# HISTORIC AND DESIGN REVIEW COMMISSION

**HDRC CASE NO:** 2019-365  
**ADDRESS:** 517 E HOUSTON ST  
**LEGAL DESCRIPTION:** NCB 422 BLK 26 W 26 FT OF 5 ARB A2  
**ZONING:** D,HS, H  
**CITY COUNCIL DIST.:** 1  
**DISTRICT:** Alamo Plaza Historic District  
**LANDMARK:** Rosenberg, Frank Building  
**APPLICANT:** Michael Litofsky  
**OWNER:** Michael Litofsky  
**TYPE OF WORK:** Storefront Modification  
**APPLICATION RECEIVED:** June 24, 2019  
**60-DAY REVIEW:** August 23, 2019  
**CASE MANAGER:** Huy Pham  
**REQUEST:**

The applicant is requesting a Certificate of Appropriateness for approval to modify a previously approved design to include a glass storefront on the E Houston Street side.

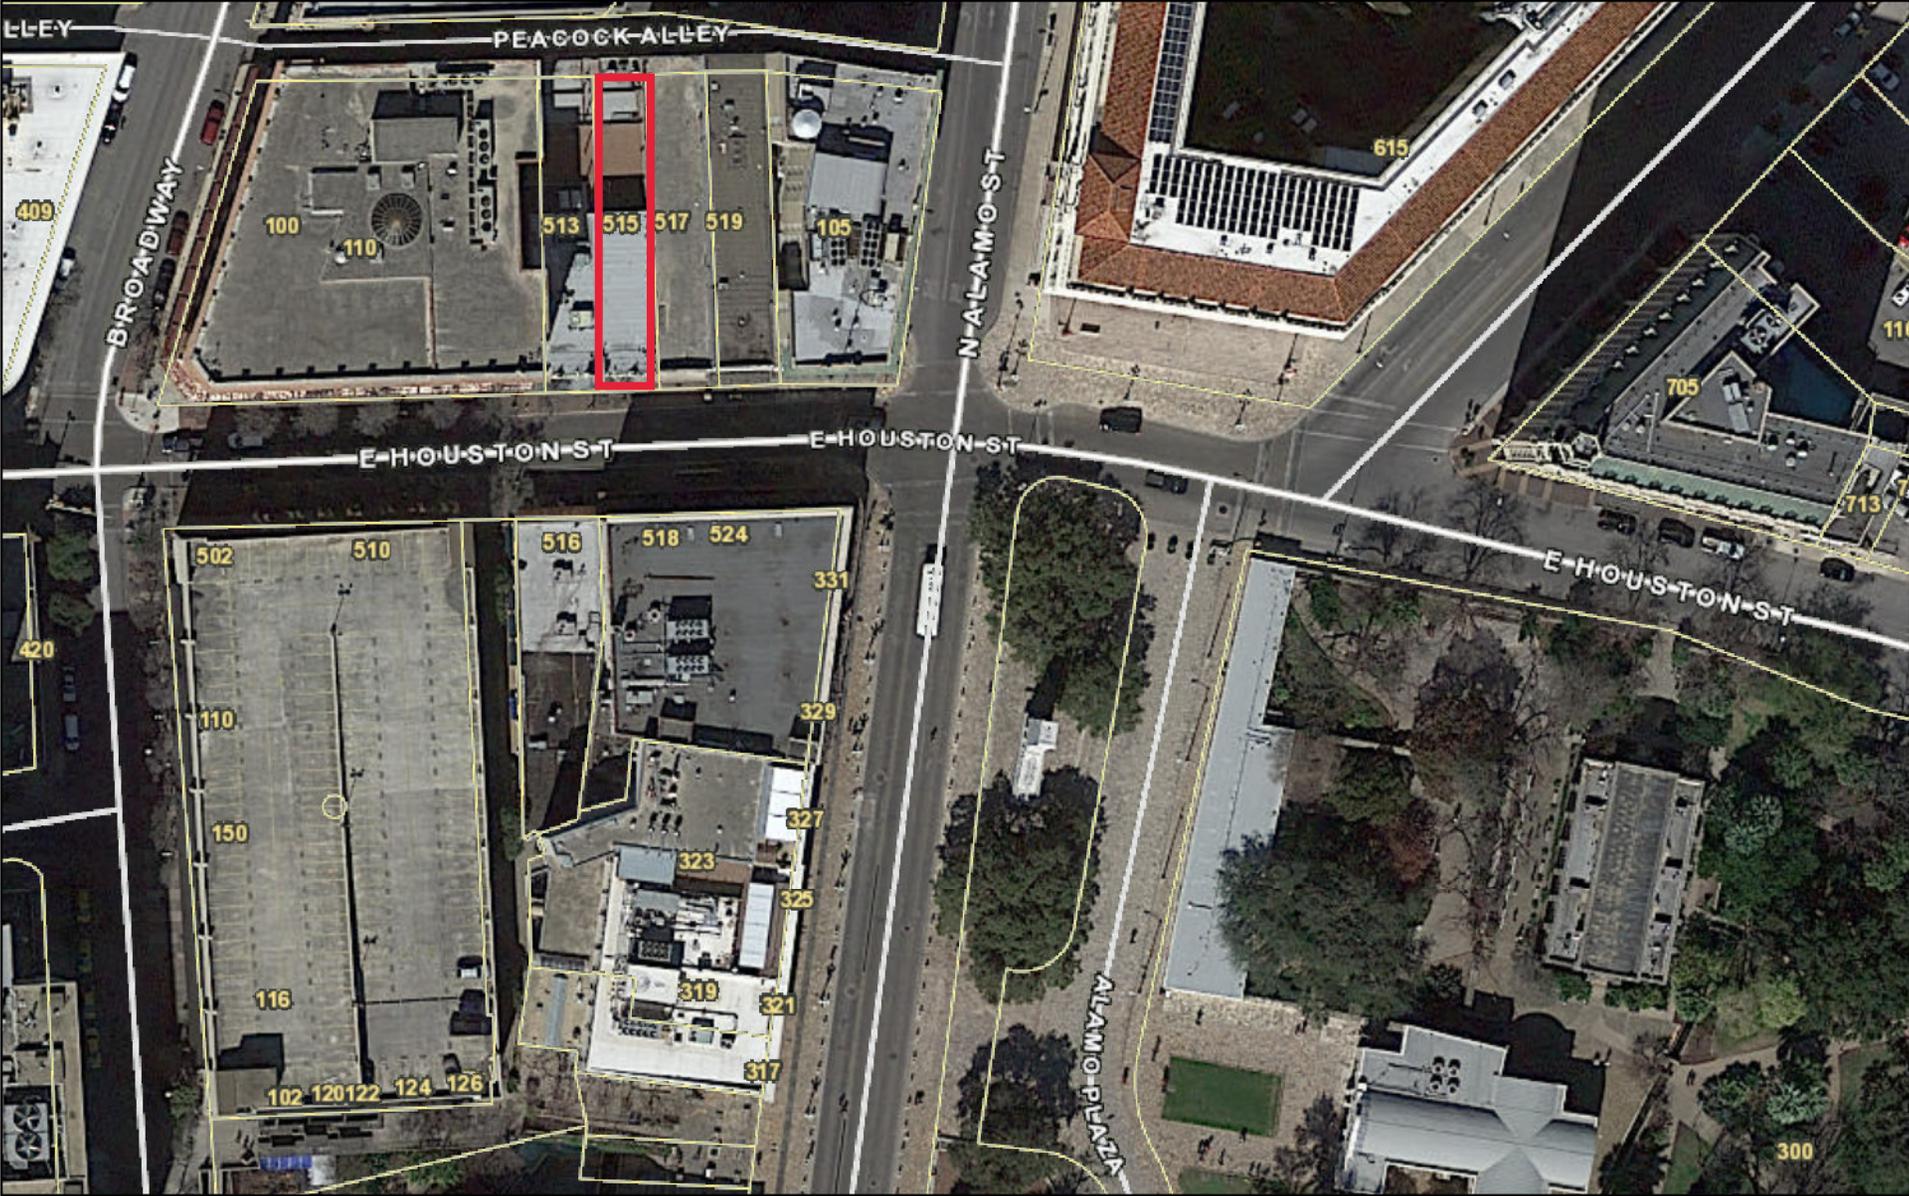
- c. **DESIGN AMENDMENT** – The applicant has proposed to install a full-glazing first-floor storefront and a

second-floor balcony with railing and centered entry. Staff finds that the proposed design would create condition where the first-floor storefront does not relate to the second-floor façade and that the proposed balcony with railing is disruptive to the Art Moderne rhyme of the flanking pilasters. Staff finds that the proposed design amendments are inconsistent with the Guidelines for Exterior Maintenance and Alterations 10.A.i and 10.B.i. and that the previously approved design is a more sensitive and appropriate treatment of the structure.

Staff does not recommend approval of the design amendment based on finding c. The applicant may submit another design that is consistent with the Guidelines or based on historic photographic evidence to be submitted for review – or continue with the design approved in May 2015 and again in May 2019.

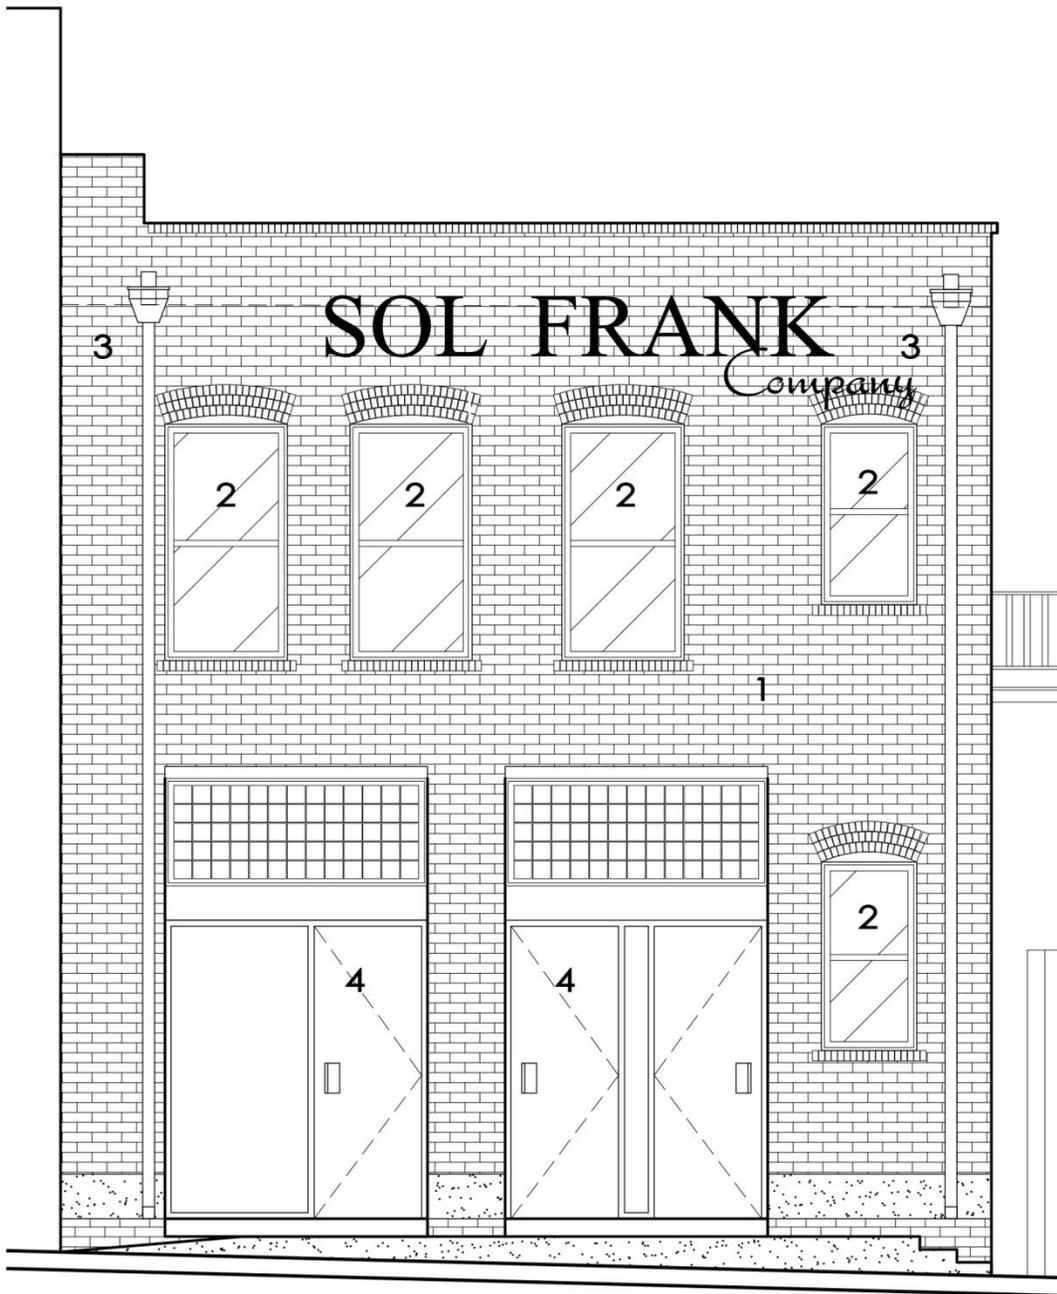
- m.** NEW DOORS - The applicant has proposed to install two (2) new doors on the Peacock Alley façade. While this is the rear of the building, in this instance the rear is proposed to be treated as the front also. The Guidelines for Exterior Maintenance and Alterations 6.A.i. does not recommend that new entrances be created where visible from the public right of way. This proposal is not consistent with the Guidelines. Staff recommends that the applicant keep the existing door openings and widths.

- 1 CLEAN AND RESTORE EXISTING BRICK
- 2 REPLACE WINDOWS
- 3 RESTORE SCUPPER, DOWNSPOUT AND DOWN LEADER
- 4 NEW DOORS

GLASS CANOPY DETAIL

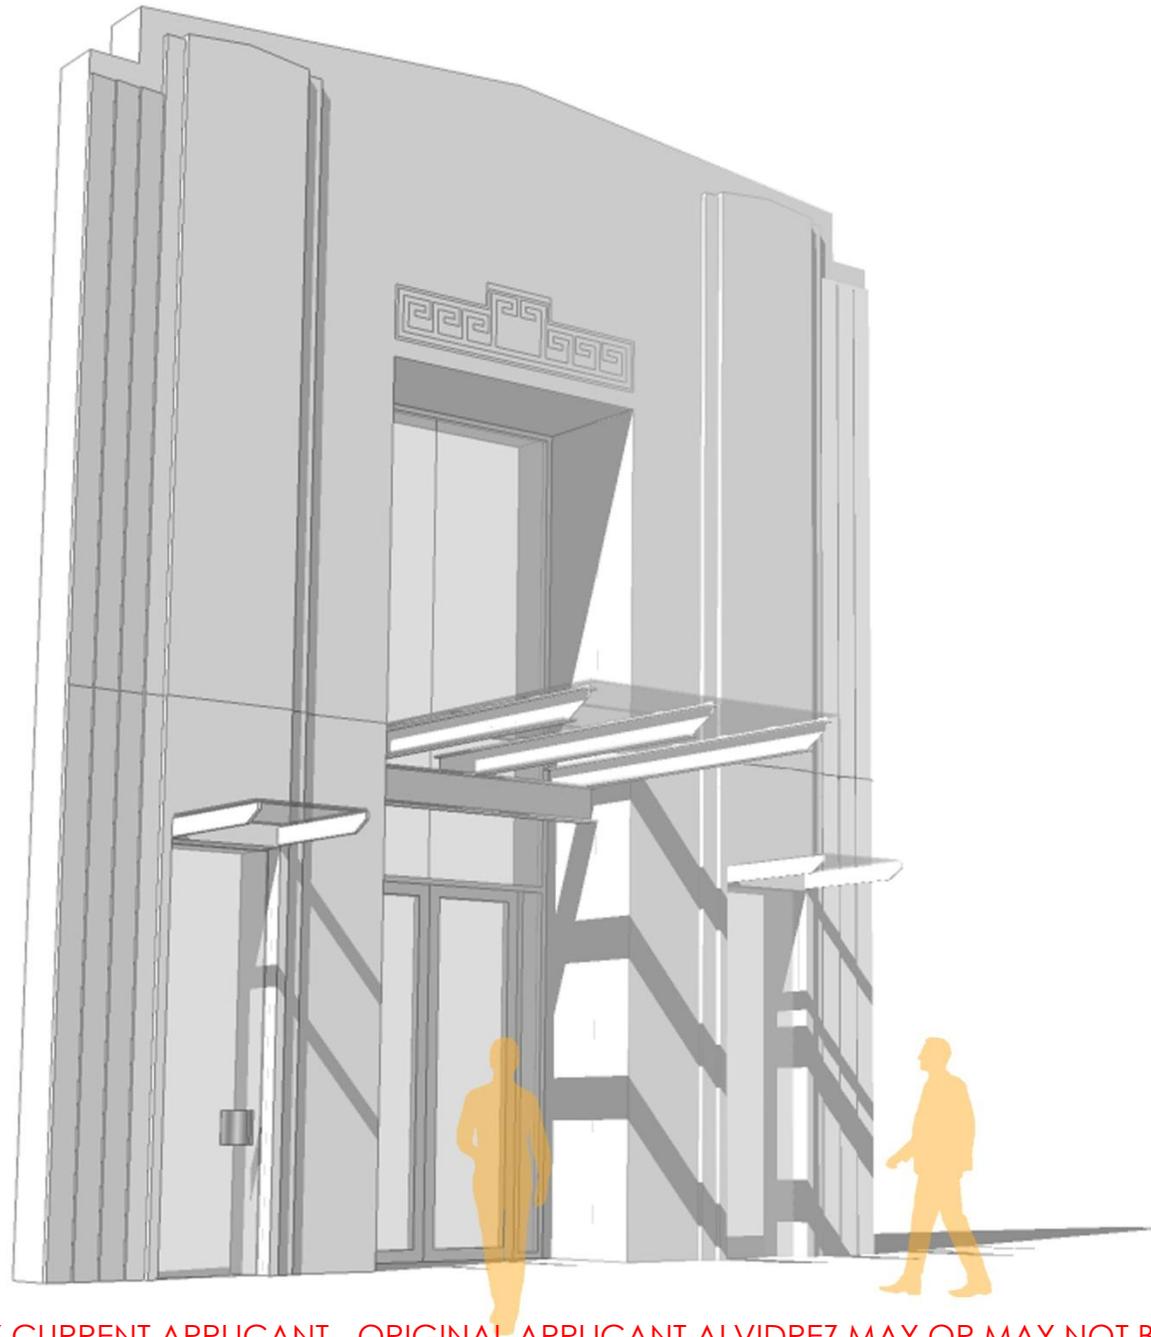
- j. CANOPY - Per a photograph dated October 2007, the Houston Street façade at 517 Houston featured a canopy which projected approximately eight (8) feet out over the sidewalk, which has since been removed. The applicant has proposed to install a projecting steel and glass canopy which is to extend over the sidewalk approximately five (5) feet and feature three (3) sections to correspond with the entrance way and the proposed new clear glass. While the profile and materials are not alike in materials to the original historic façade, staff finds that the light appearance of the thin steel and glass canopy does not distract from the historic façade and is appropriate in this instance.
